Early Grading Permit - Final Drainage Report

Trinity Ranch Estates, Filing No. 1 El Paso County, Colorado

Project #: 096726003

PCD Filing No.: XXXX **SP268**

DETENTION BASIN STAGE-STORAGE TABLE BUILDER

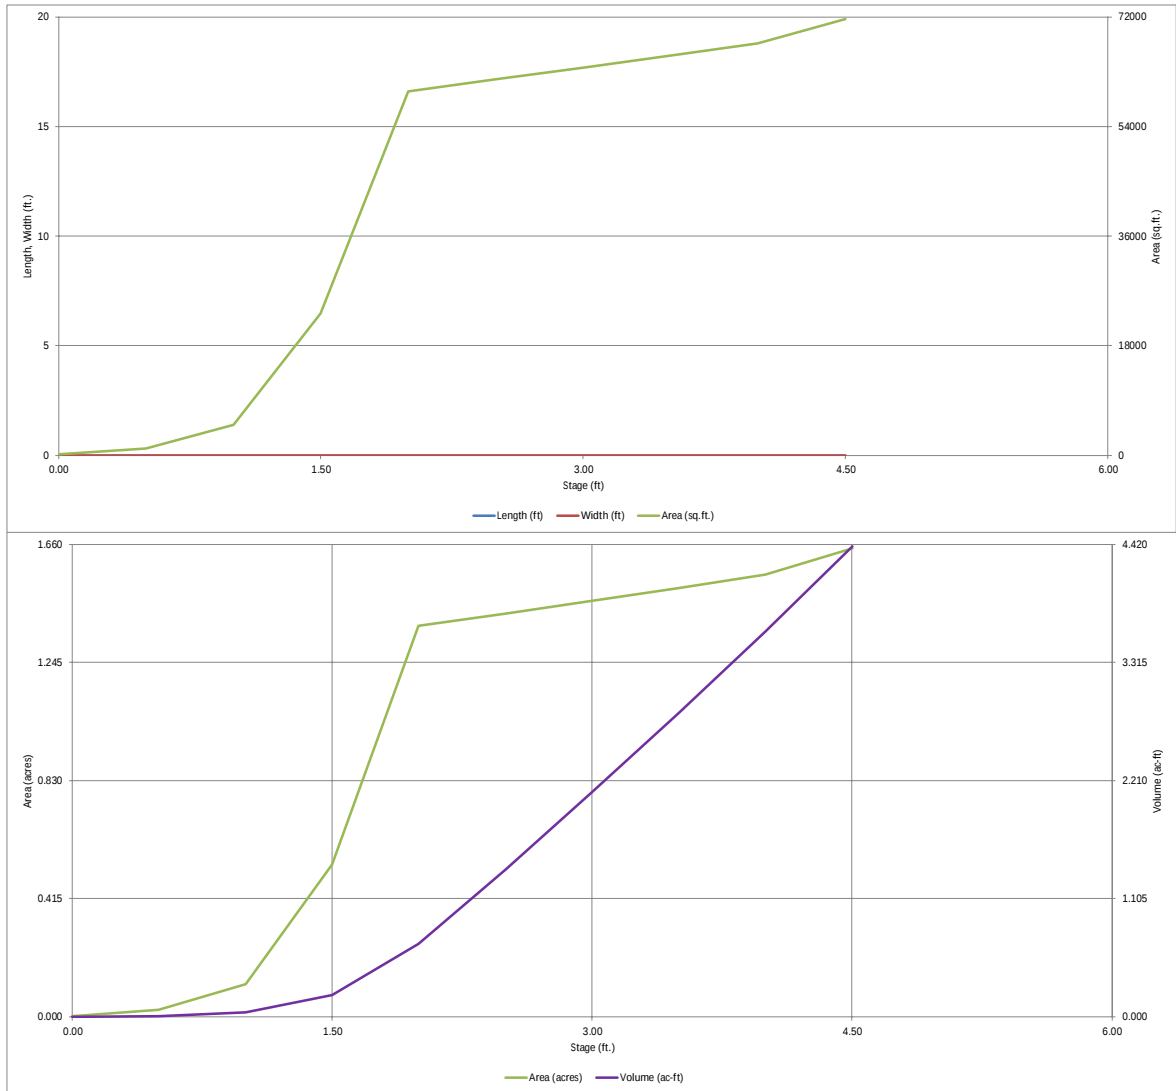
Specify these orifice elevations in GEC plan

Add spillway dimensions.

Since the TSBs will be left in during the final condition they should meet the drain time requirements indicated in Senate Bill 15-212. Please revise accordingly.

DETENTION BASIN STAGE-STORAGE TABLE BUILDER

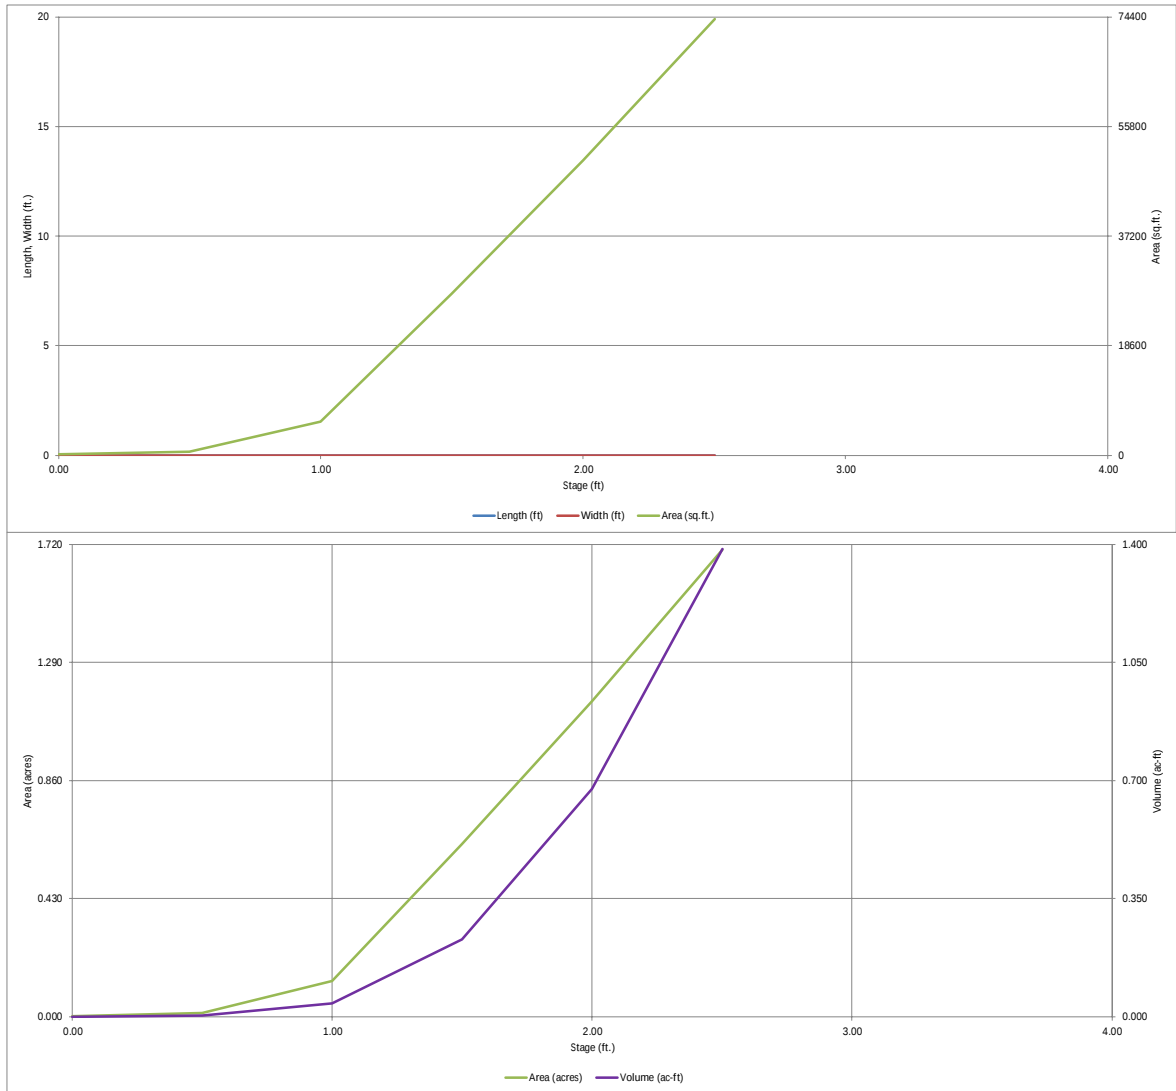
Specify these orifice elevations in GEC plan

Add spillway dimensions.

TRINITY RANCH
EL PASO COUNTY, COLORADO
PRELIMINARY PLAN
EXISTING DRAINAGE MAP

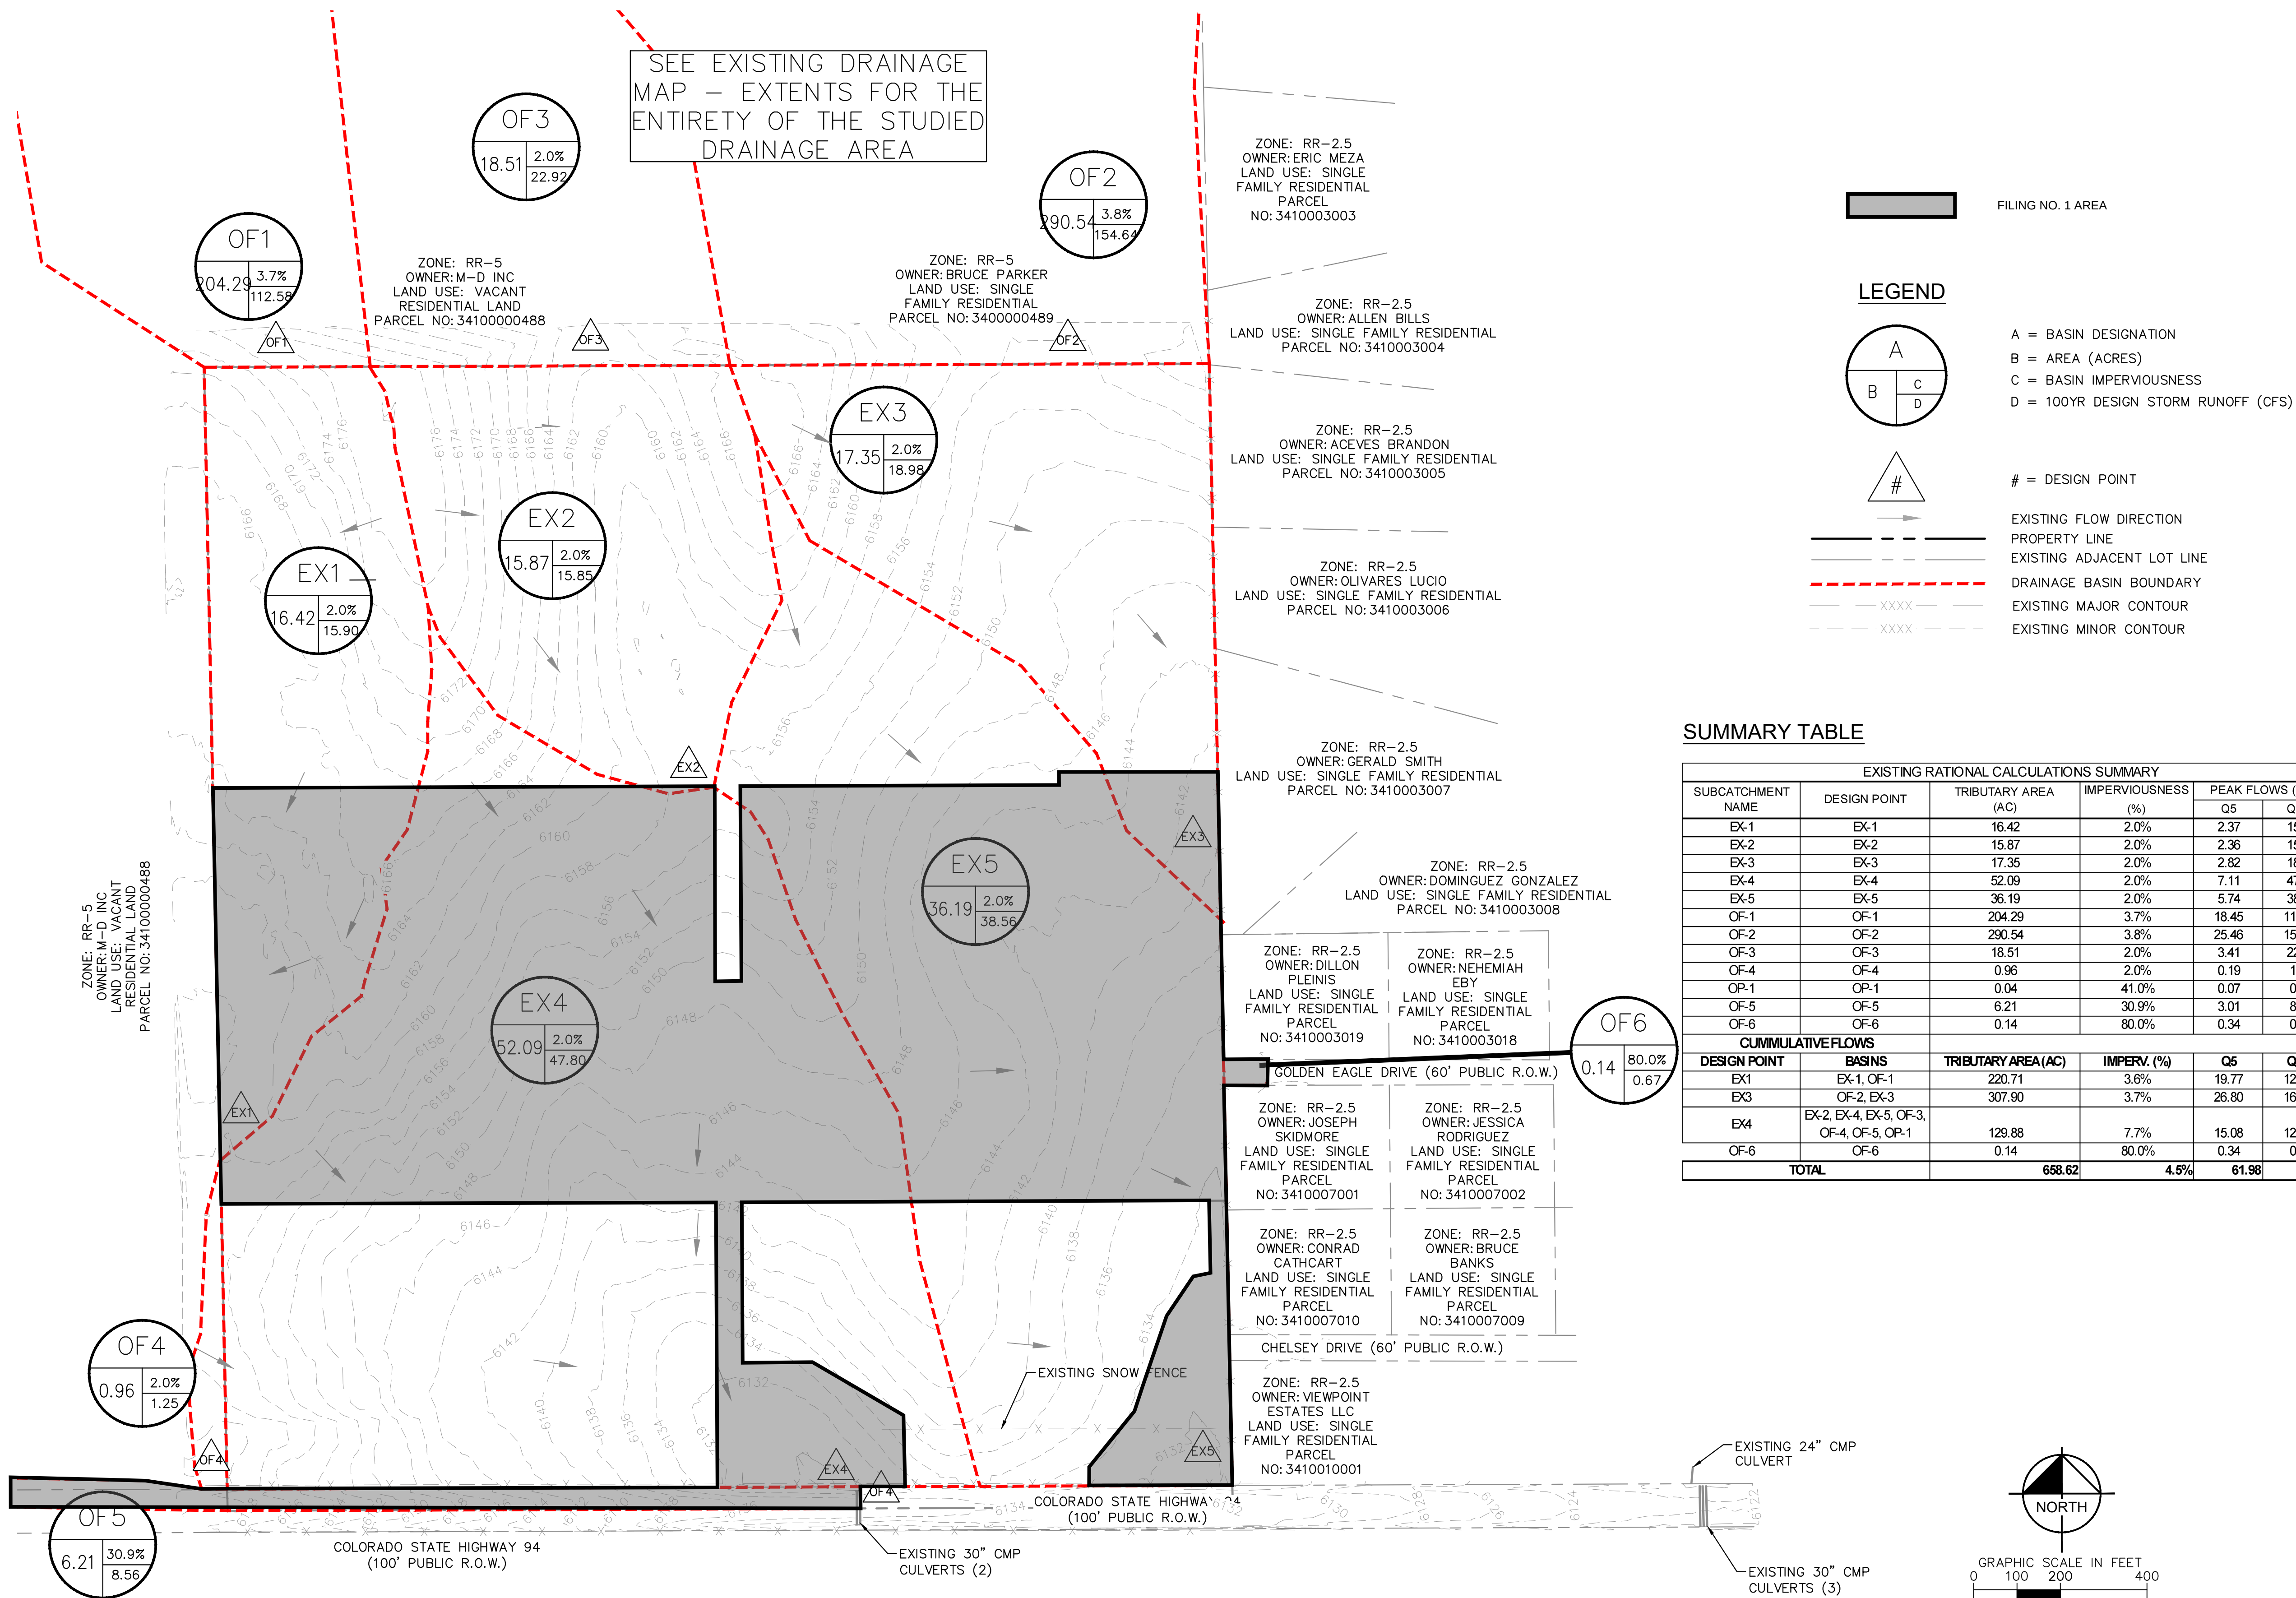
Clarify that this is the early grading LOD, since the shaded area includes some of Filing 3 and omits some of the Filing 1 area shown in the prelim plan drawings

Since this report is specific to the early grading, remove the "proposed areas of exclusion" and only shade areas that will be excluded from WQ with early grading (should be everything since it will be seeded).
